ADDENDUM 001

Date: **May 27, 2026**
To: **Construction Documents, Dated 05.18.26**
Project: **#3038 ASU Career Readiness, Education, & Skills Training Center**

ROOF PLAN
A4.00

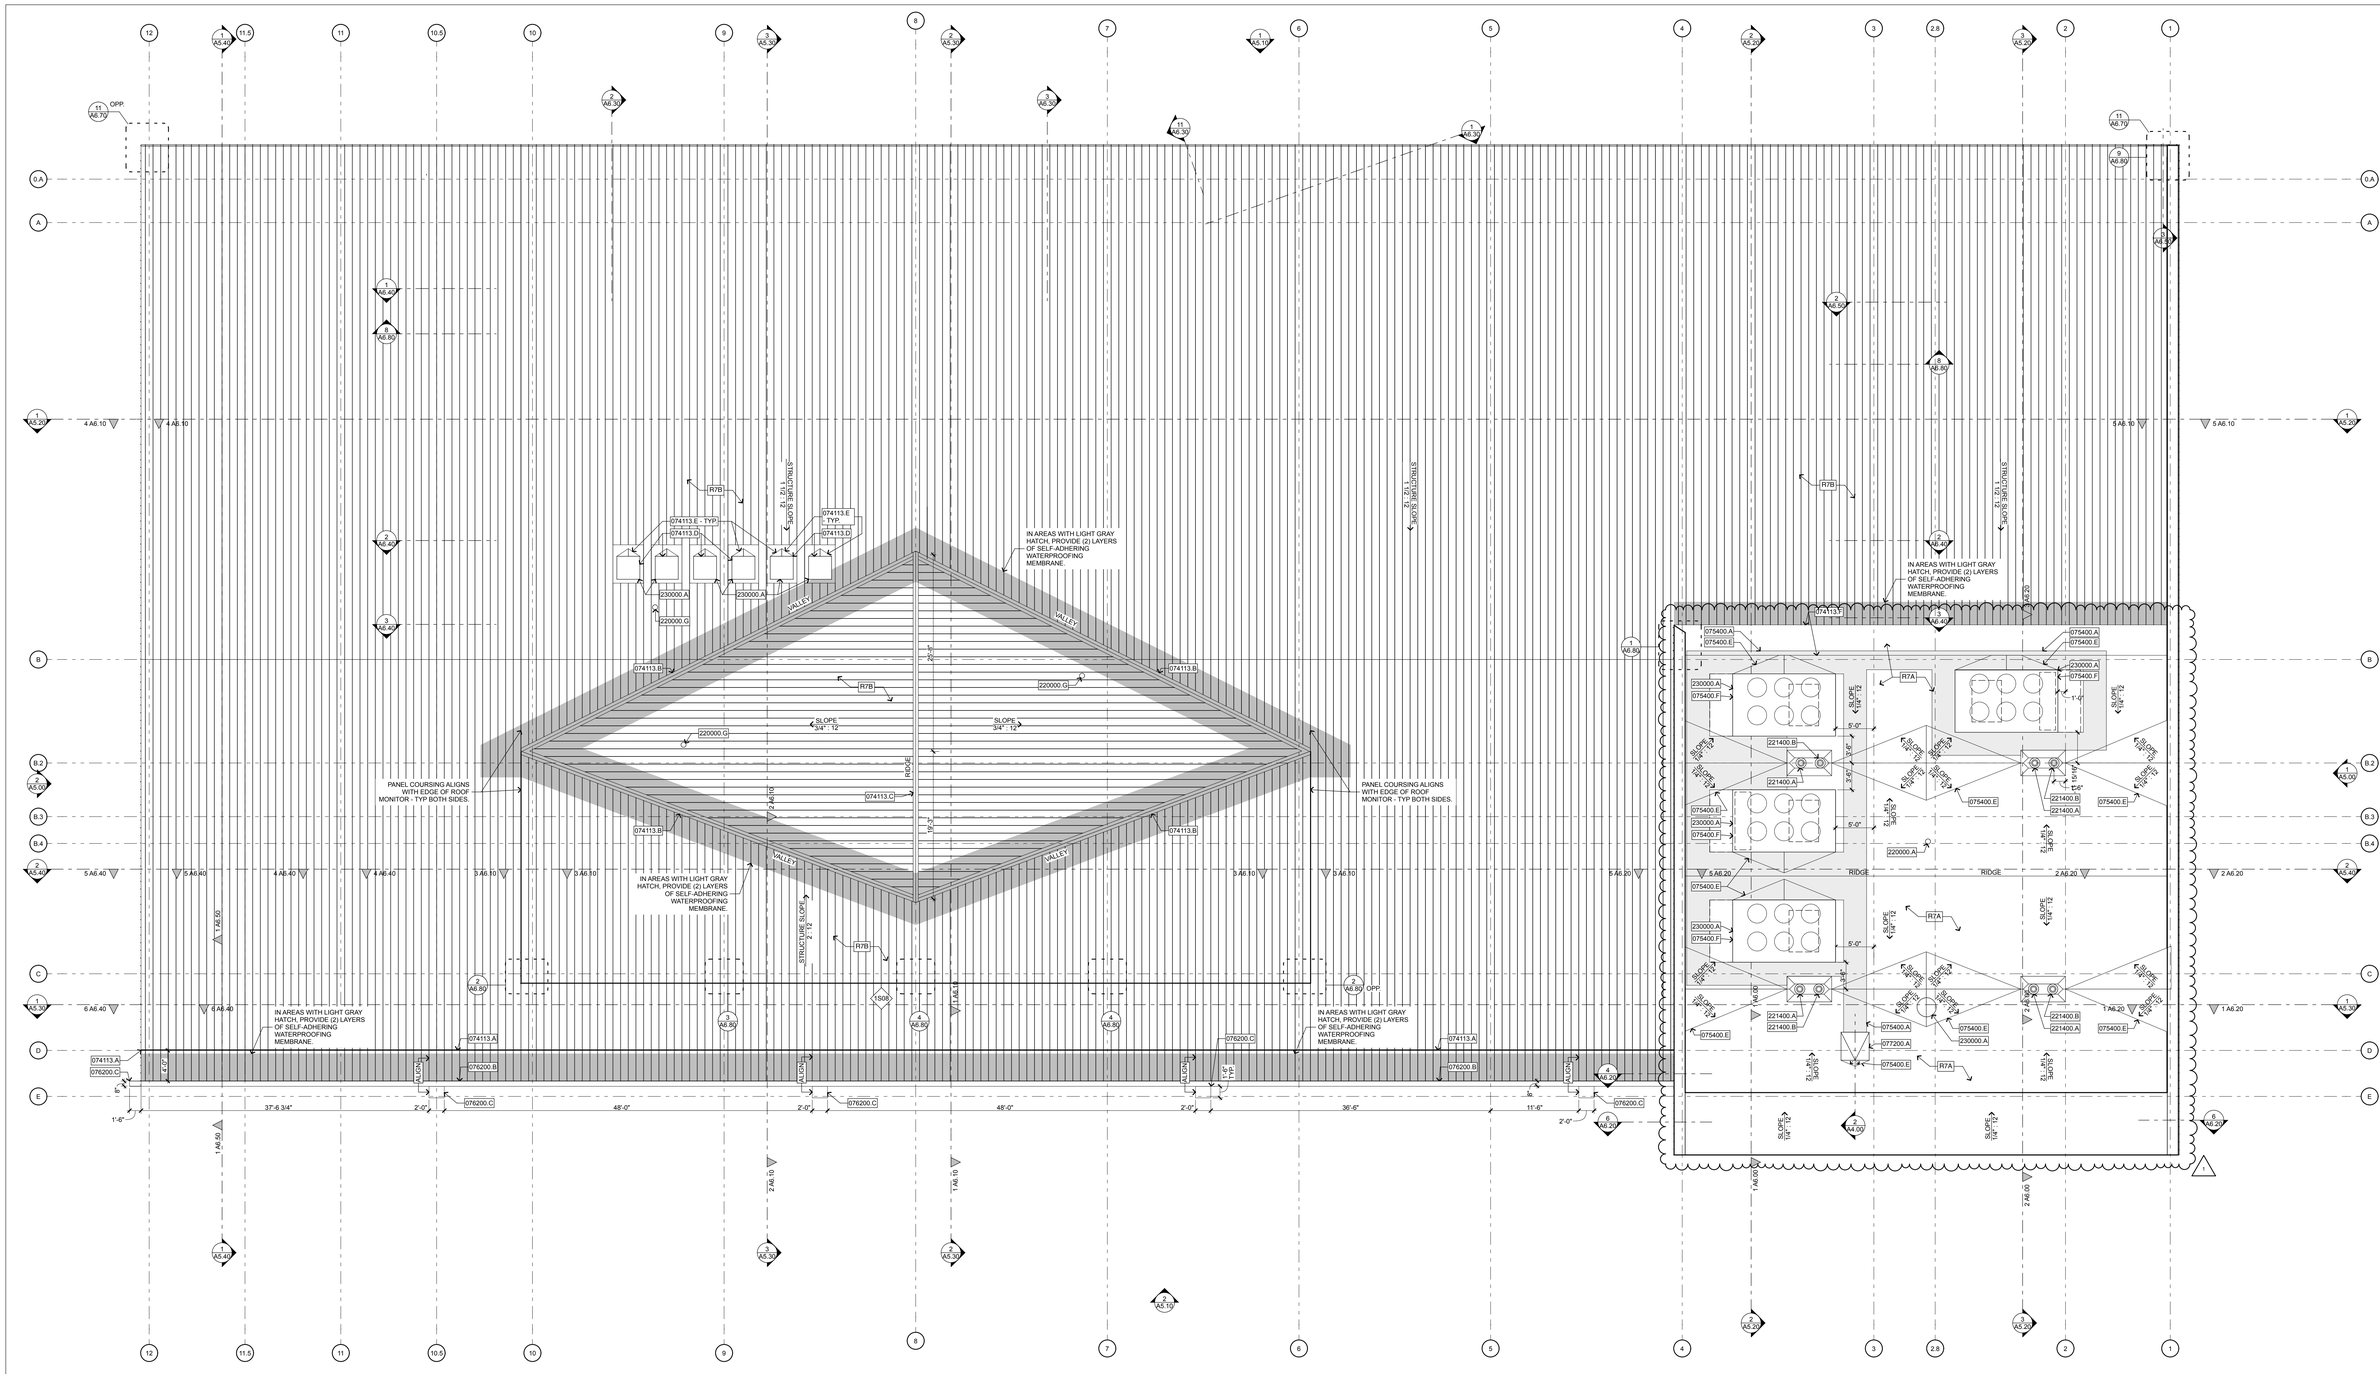
f. **REPLACE** Sheet A4.00 ROOF PLAN with the attached for the following revisions:
   1. **ADD** (2) Roof drains and associated overflow drains
   2. **REVISE** roof cricketing to reflect new drain locations.
   3. **REVISE** mechanical equipment locations
   4. **REVISE** walkpad locations per new equipment layout.
   5. **REVISE** keynote 220000.A, 221400.A & 221400.B to include roof detail reference number.
   6. **ADD** keynote 075400.F.
   7. **REVISE** Axon Details 3 & 4 to indicate standing seam wall panels below the gutter in lieu of metal fascia panels.

ROOF DETAILS
A4.20

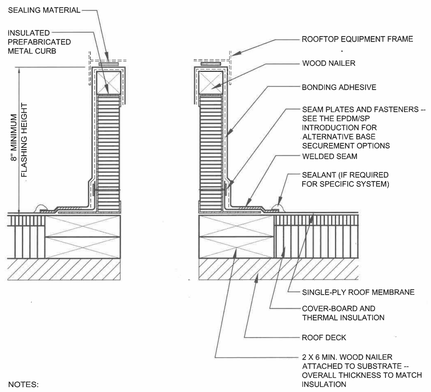
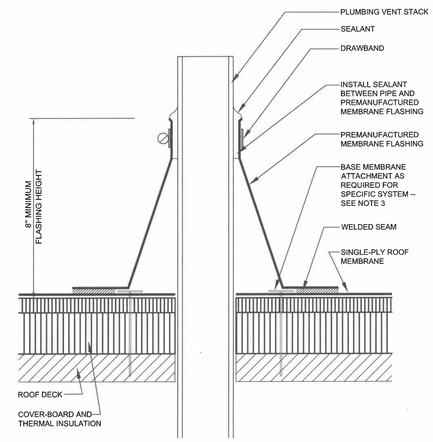
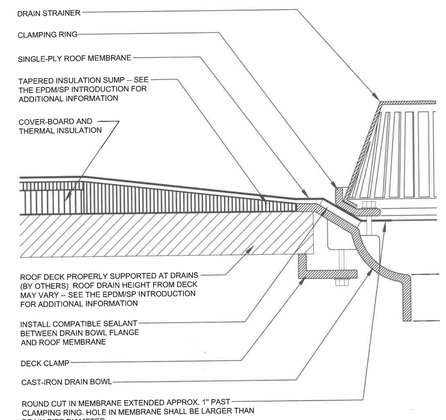
g. **ADD** Sheet A4.20 ROOF DETAILS
   1. **ADD** 2007 NRCA details SP-13S, SP-19S & SP-22S.

2 EAST ELEVATION
SCALE: 1/8" = 1'-0"

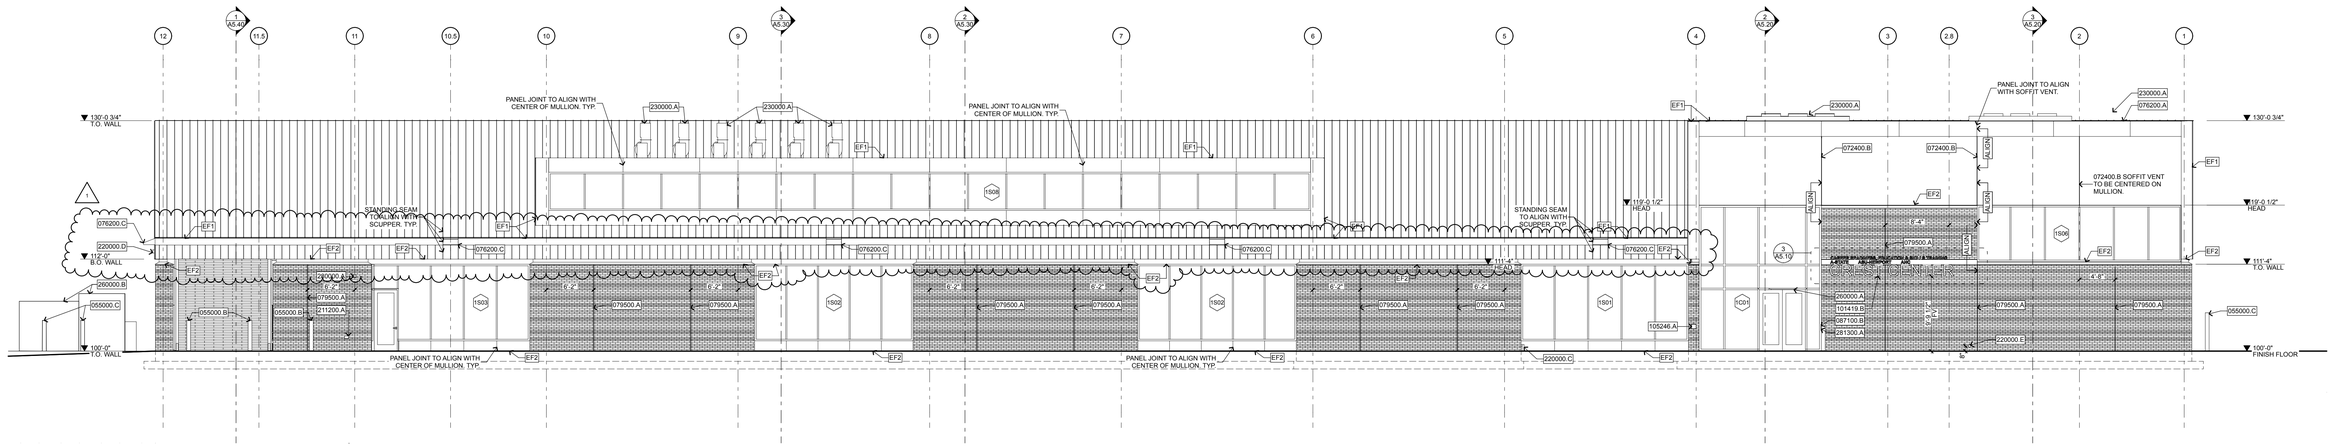
h. **REPLACE** Sheet A5.10 BUILDING ELEVATIONS with the attached for the following revisions:
   1. **REVISE** East Elevation to indicate standing seam wall panels below the gutter in lieu of metal fascia panels.

BUILDING ELEVATIONS
A5.10

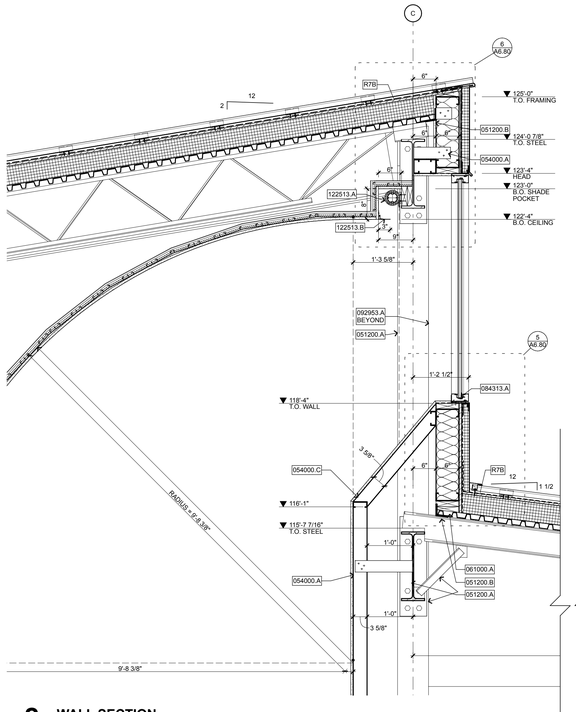
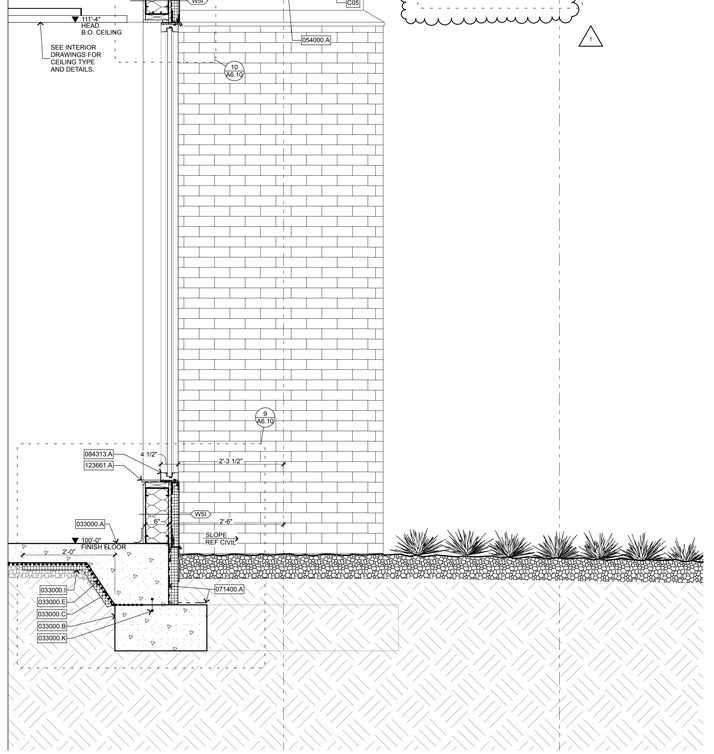
i. **REPLACE** Sheet A6.10 WALL SECTIONS & DETAILS with the attached for the following revisions:
   1. **REVISE** WALL SECTION 1 & 2 to indicate standing seam wall panels below the gutter in lieu of metal fascia panels.

7 SECTION DETAIL
SCALE: 1 1/2"= 1'-0"

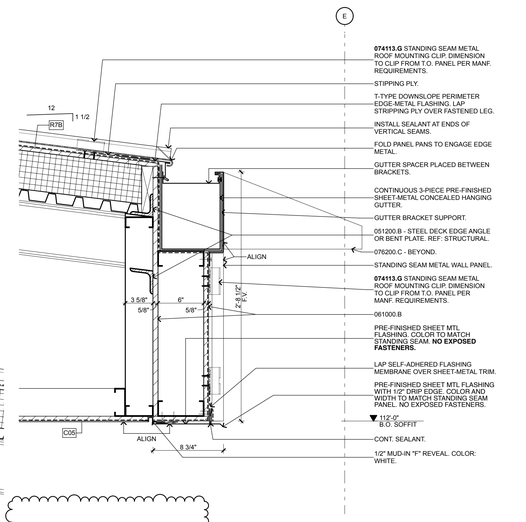
j. **REPLACE** Sheet A6.80 PLAN DETAILS & SECTION DETAILS with the attached for the following revisions:
   1. **REVISE** SECTION DETAIL 7 to indicate standing seam wall panels below the gutter in lieu of metal fascia panels.

HVAC FLOOR PLAN
M2.1

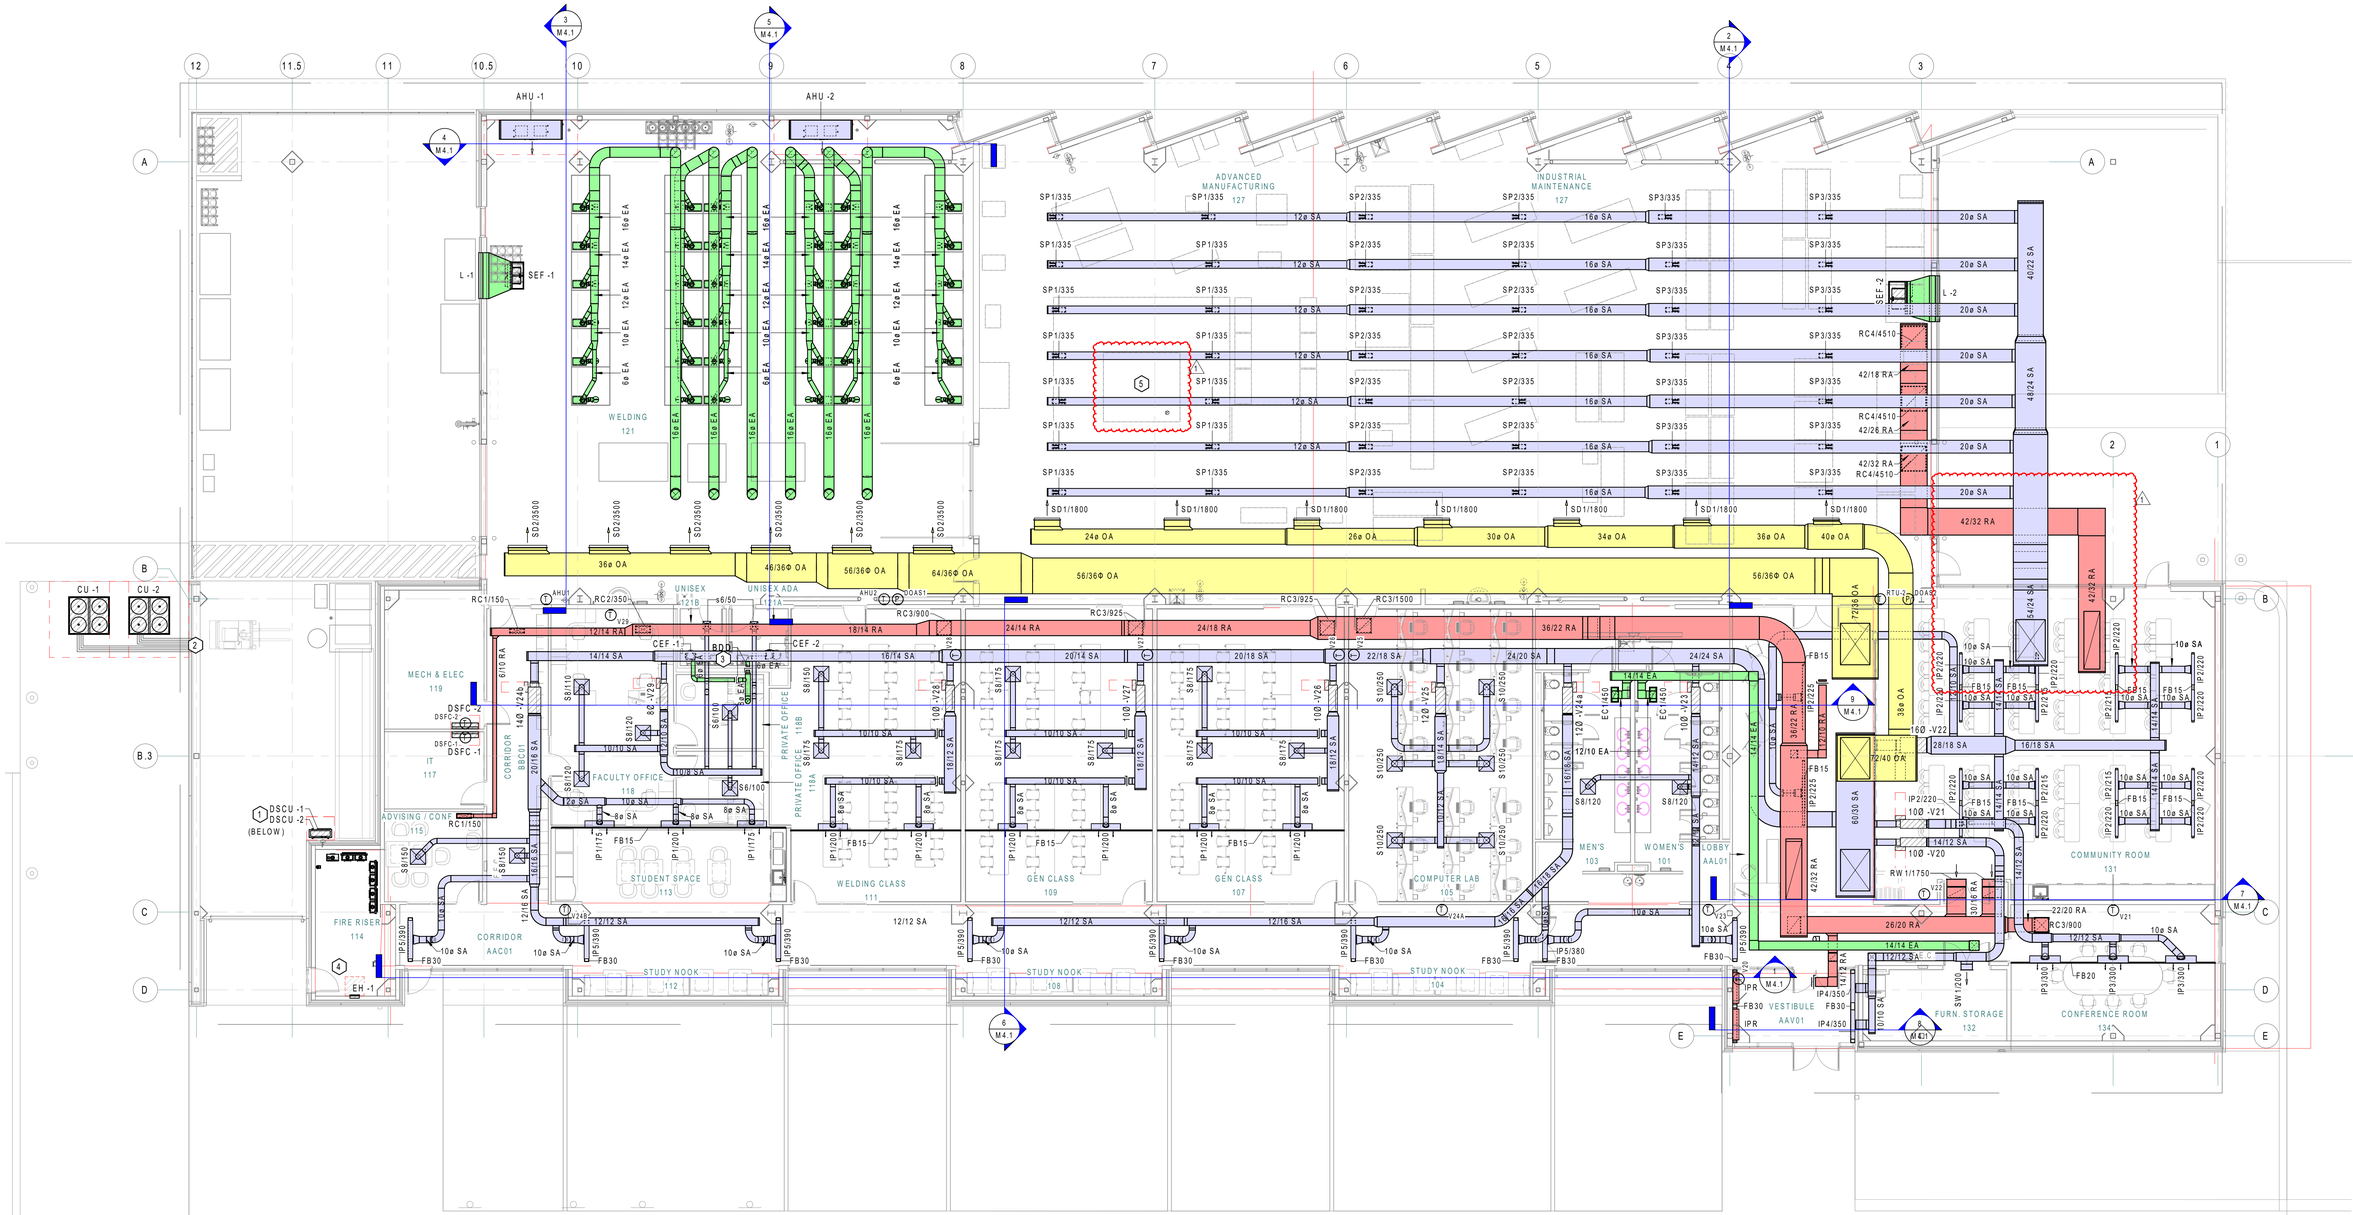
k. **REPLACE** Sheet M2.1 HVAC FLOOR PLAN with the attached for the following revisions:
   1. **REVISE** mechanical equipment locations
   2. **ADD** Keynote #5 for Owner-Furnished Fiber Laser Cutter Coordination
